APPLICANT: Consumers Power Company  
FACILITY: Midland Plant, Units 1 and 2  
SUBJECT: Summary of September 8, 1981 Meeting on Seismic Input Parameters

On September 8, 1981, the NRC staff met in Bethesda, Maryland with Consumers Power Company (the applicant) to discuss Part III of a report on the Midland site specific response spectra, "Seismic Hazard Analysis", February 1981. Staff review of this report was requested by the applicants letter of August 11, 1981. Also represented were members of the applicants consultant, Westco Geophysical Corporation. Meeting attendees are listed by Enclosure 1. The meeting agenda consisted of nine questions raised by the staff during its review and attached to the September 8, 1981 meeting notice.

Attachment  
Midland Nuclear Plant  
Draft Agenda for Meeting on Part III  
Seismic Hazard Analysis

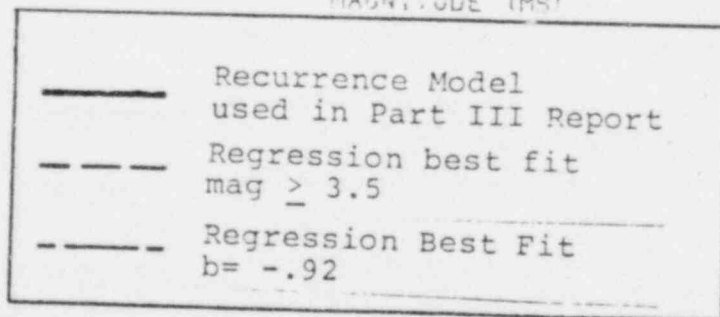
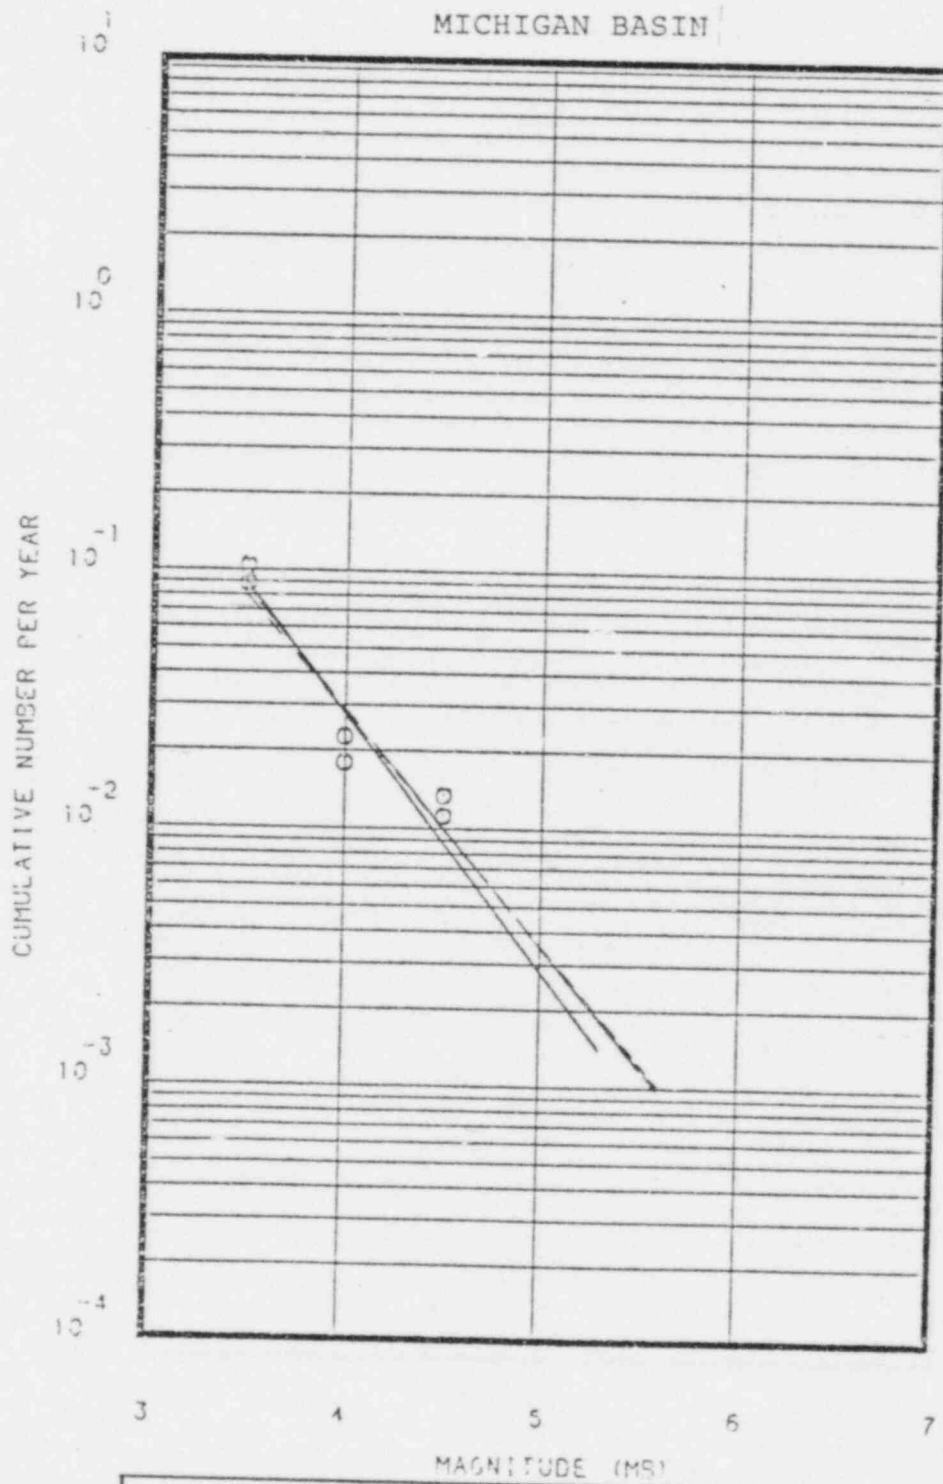
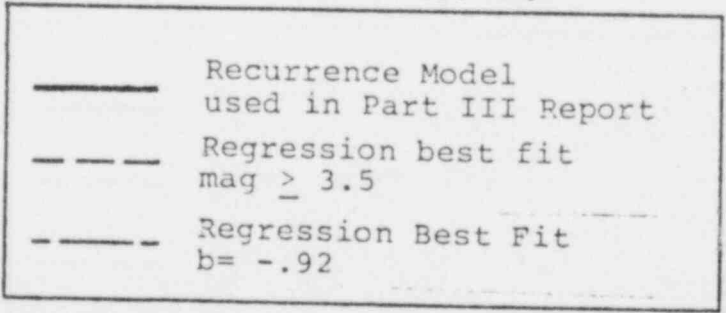
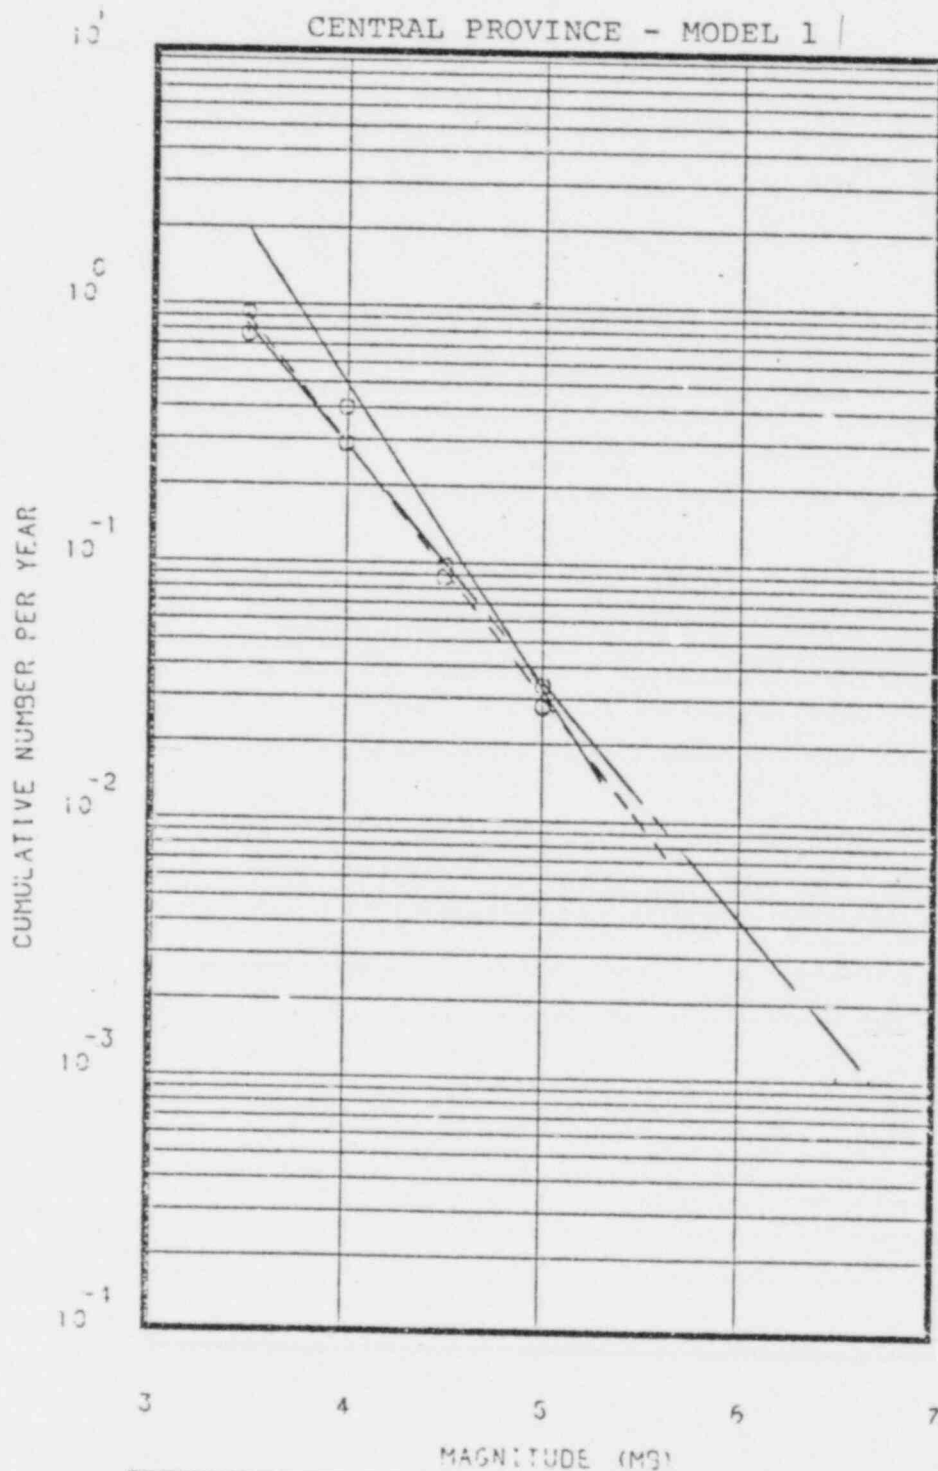
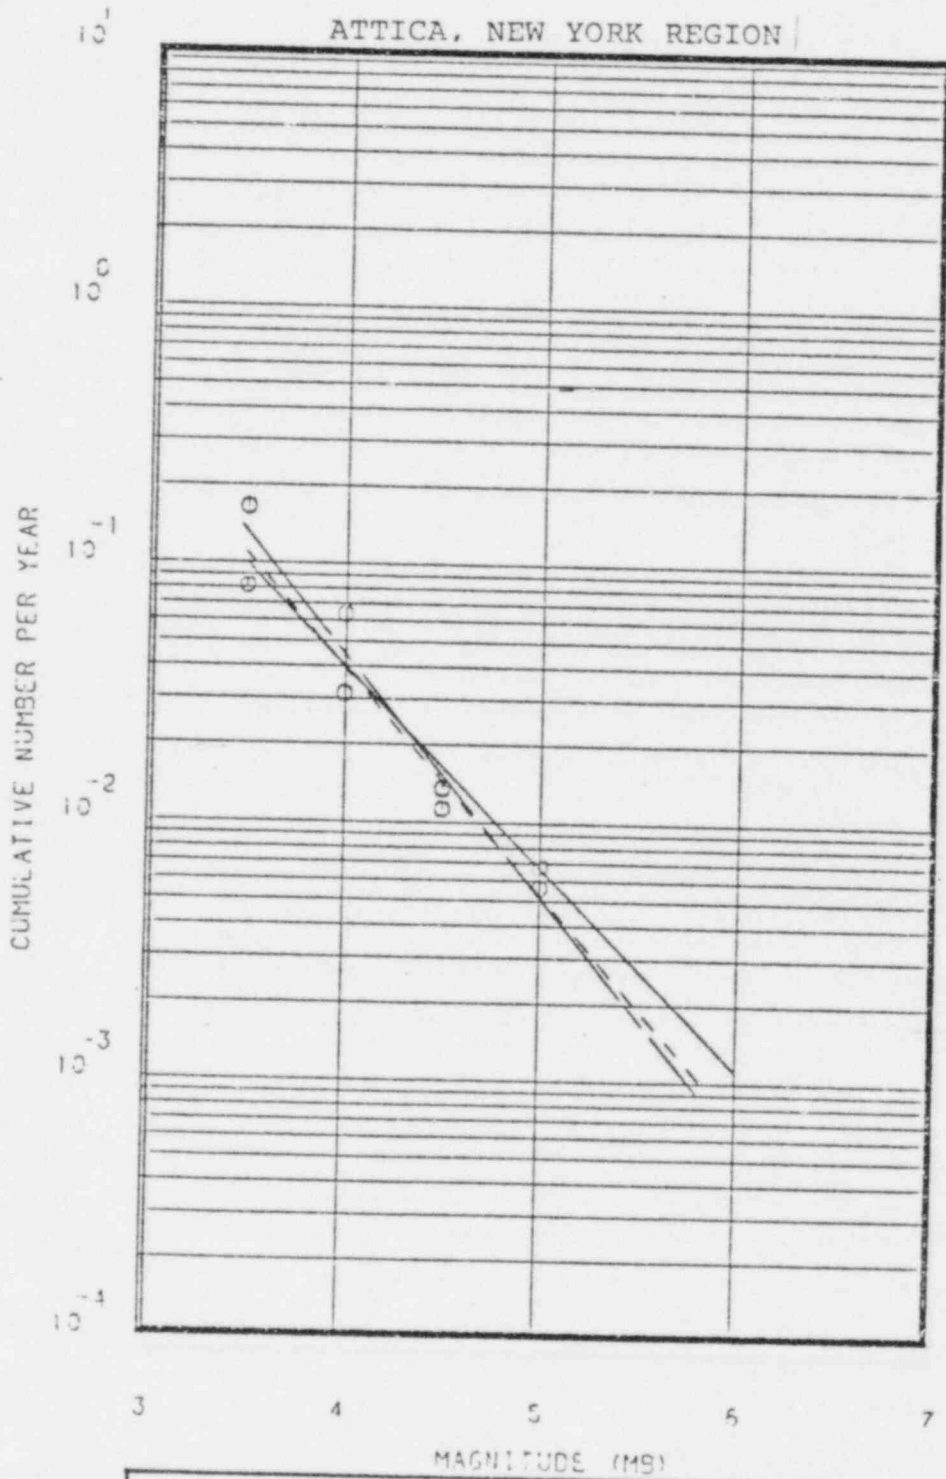
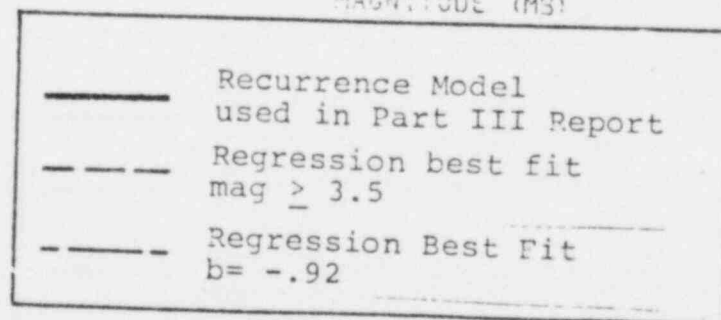
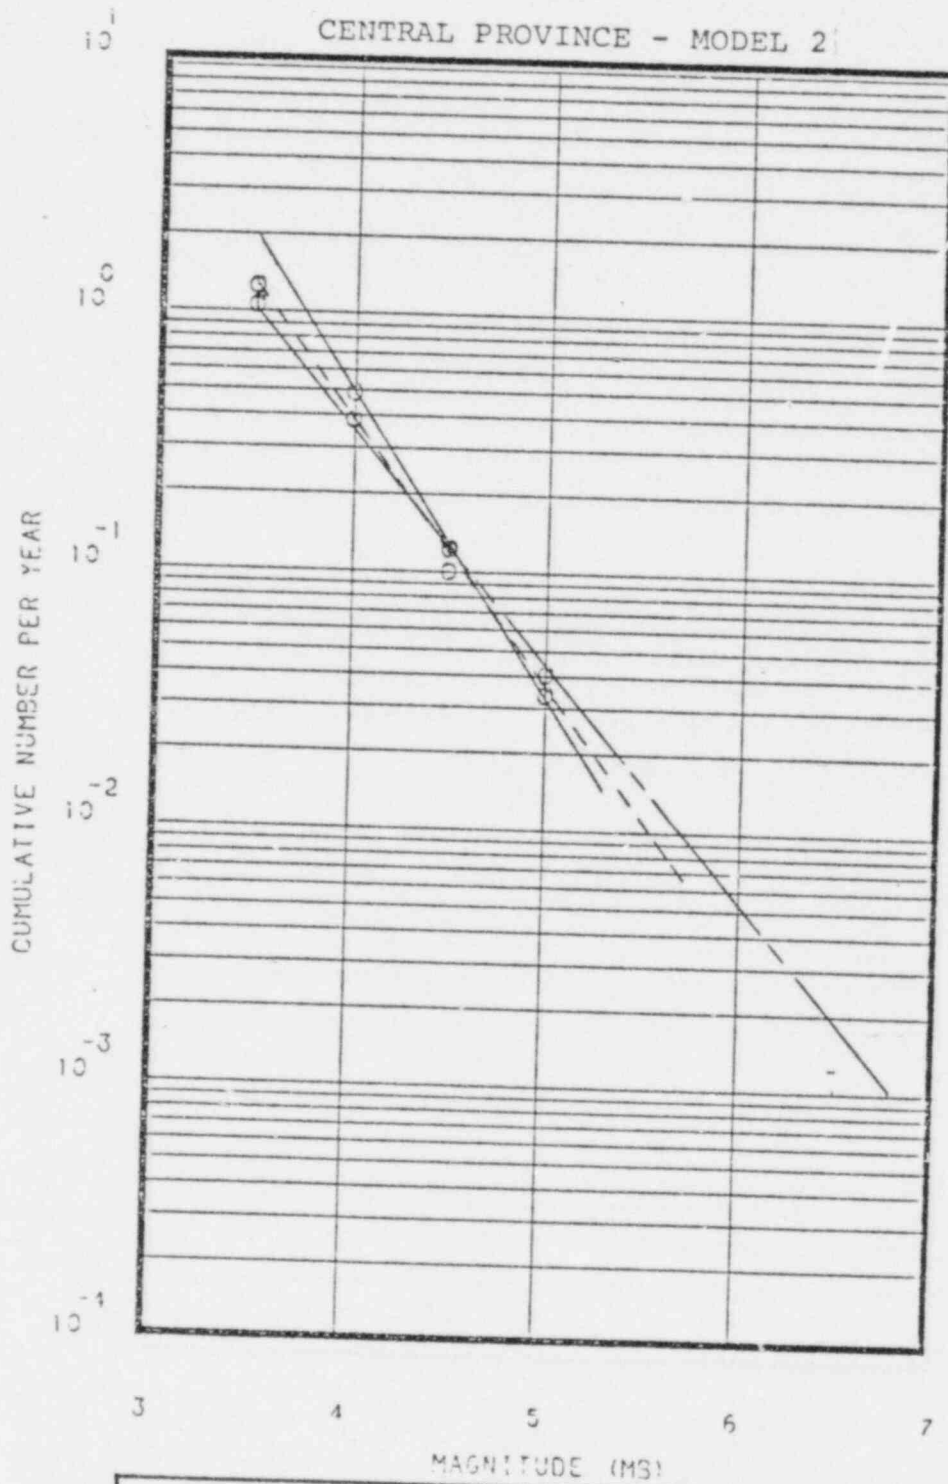
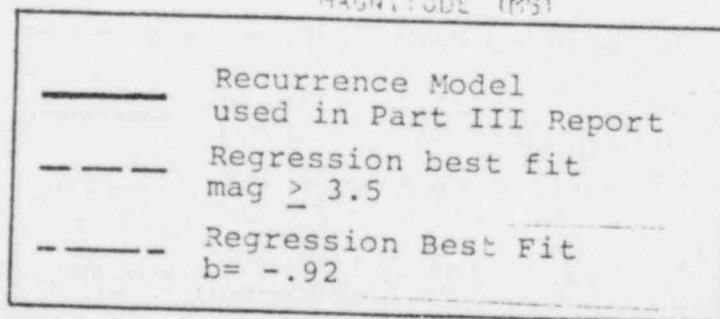
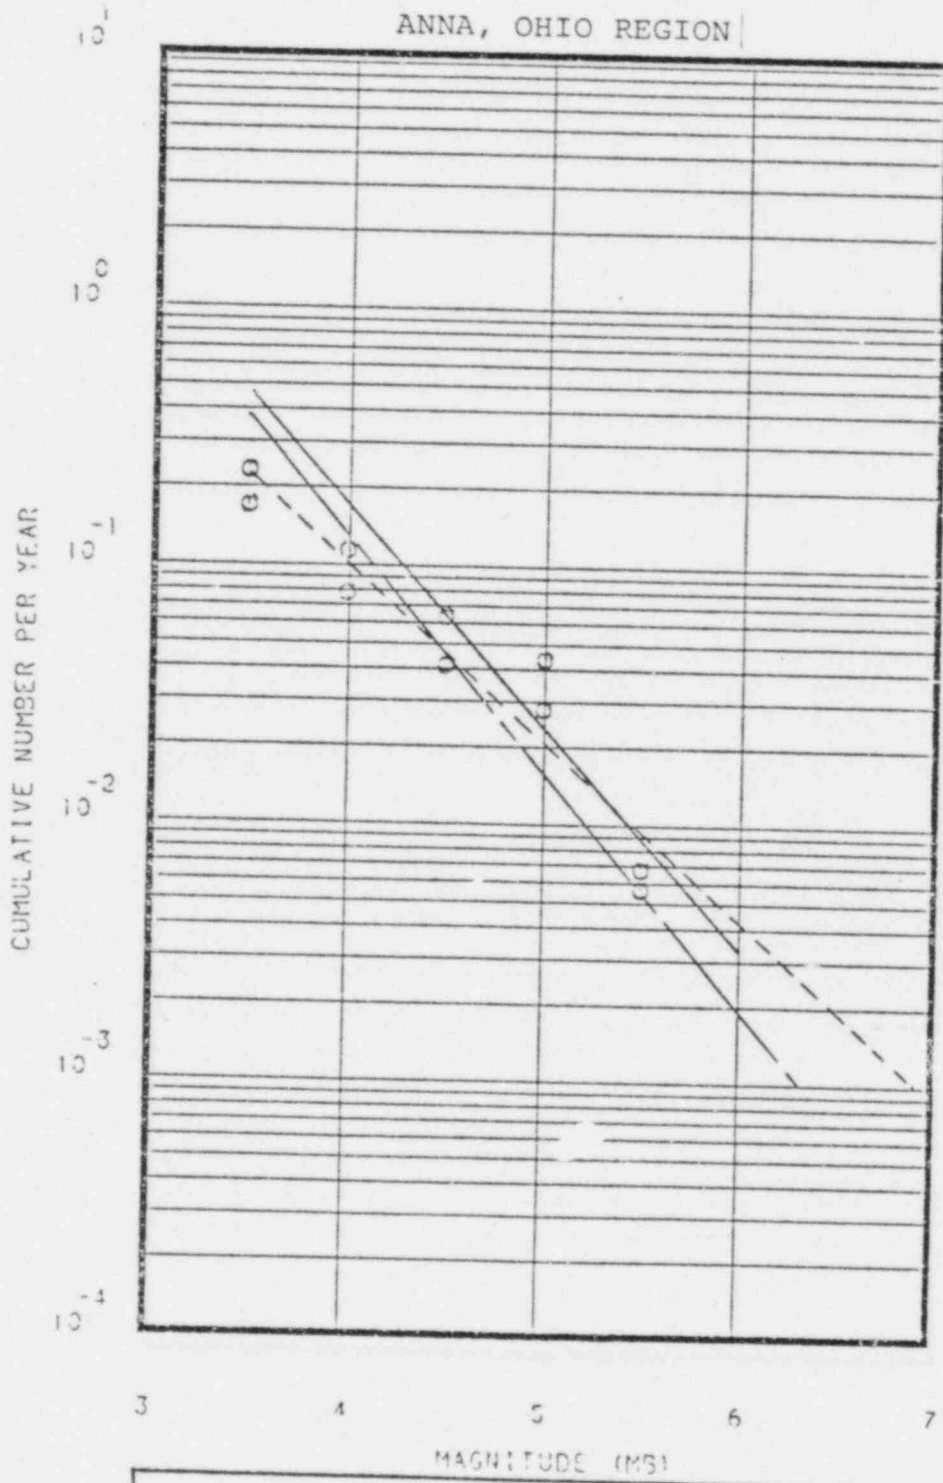
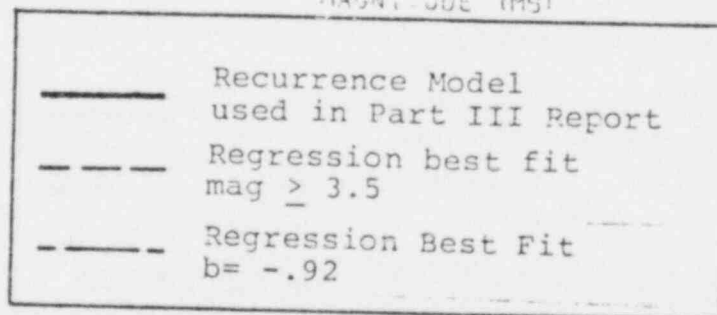
2. Provide plots of the annual number of earthquakes versus magnitude (it is not necessary to normalize to a uniform area) for all source zones similar to figures 5-8. These plots should show the actual data points along with the regression best fit line.

——— Recurrence Model  
 used in Part III Report  
 - - - - Regression best fit  
 mag  $\geq$  3.5  
 - · - · Regression Best Fit  
 b =  $-.92$
